RENESAS TECHNICAL UPDATE

Product Category	MPU/MCU		Document No.	TN-RL*-A081A/E	Rev.	1.00
Title	Restriction on MCU Activation when Power is Supplied		Information Category	Technical Notification		
Applicable Product	RL78/L1A Group	Lot No.	Reference Document	RL78/L1A User's Manual: Hardware Rev. 1.00 R01UH0636EJ0100 (Aug. 2016)		
		All lots

1. Restriction on MCU Activation when Power is Supplied to V_{DD} and AV_{DD}

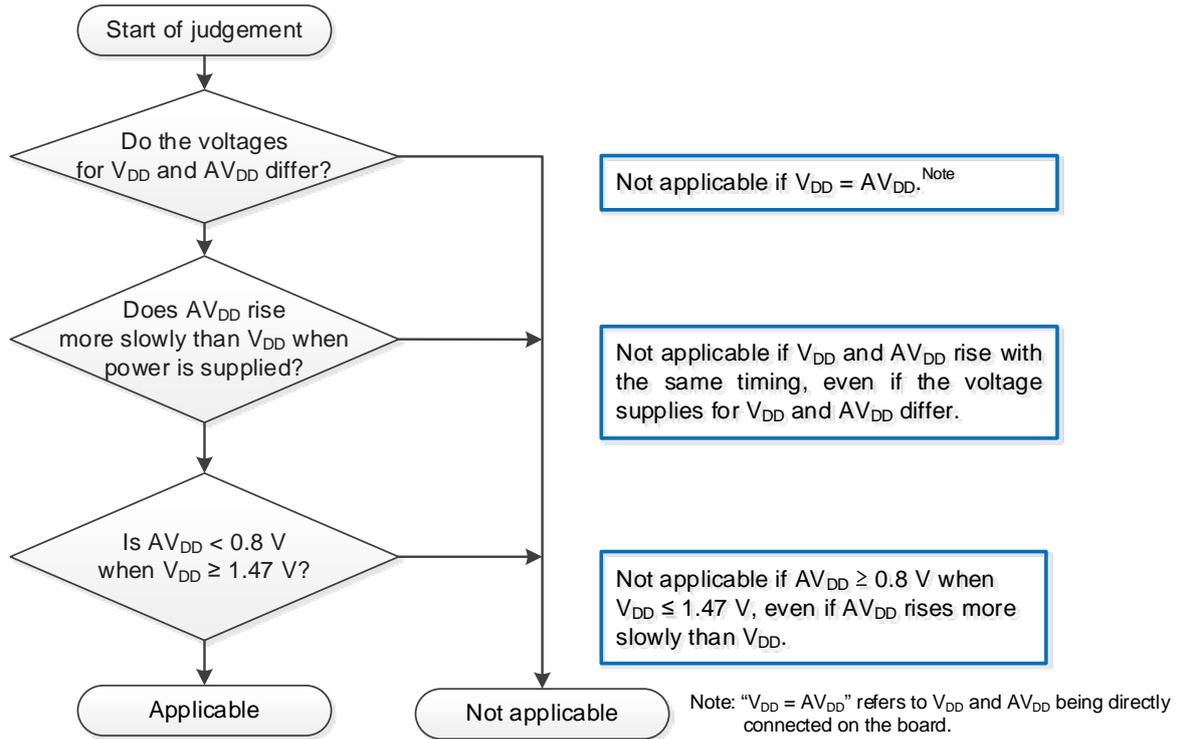
The MCU may not start normally when AV_{DD} is below 0.8 V on release from the internal reset state caused by a power-on reset (POR) in cases where the voltages for V_{DD} and AV_{DD} differ and AV_{DD} rises more slowly than V_{DD} when power is initially supplied.

Note: Voltage at the time of release from the POR

$$V_{POR} = 1.51 \text{ V} \pm 0.04 \text{ V}$$

In cases where the voltage supplies for V_{DD} and AV_{DD} differ and AV_{DD} rises more slowly than V_{DD} when power is initially supplied, use either of the workarounds below to avoid incorrect behavior of the MCU.

- Apply measures on the board so that AV_{DD} reaches at least 0.8 V before V_{DD} reaches or exceeds 1.47 V. (workaround 1)
- Hold the pin reset until V_{DD} reaches or exceeds 1.47 V and AV_{DD} reaches or exceeds 0.8 V. (workaround 2)

1.2 Flow for judging whether or not the restriction applies

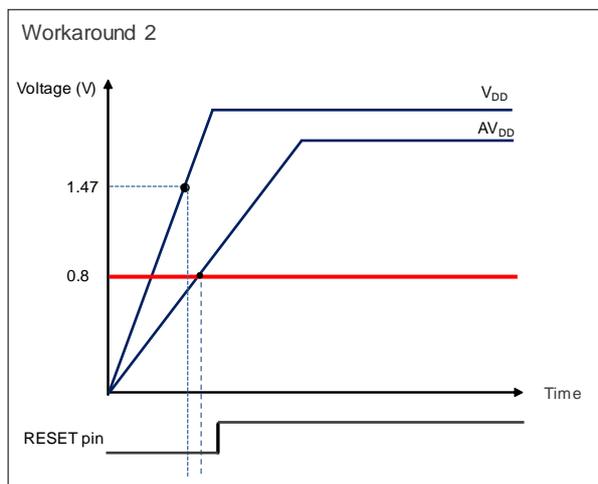
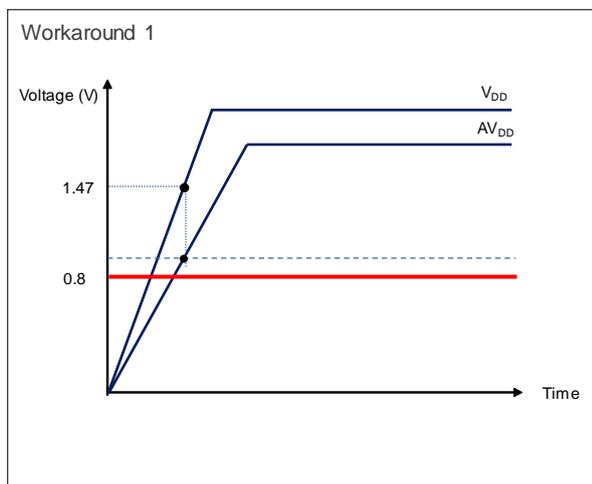
Cases where the restriction is not applicable:

The MCU starts normally on release from the power-on reset state.

Cases where the restriction is applicable:

The MCU may not start normally on release from the power-on reset state.
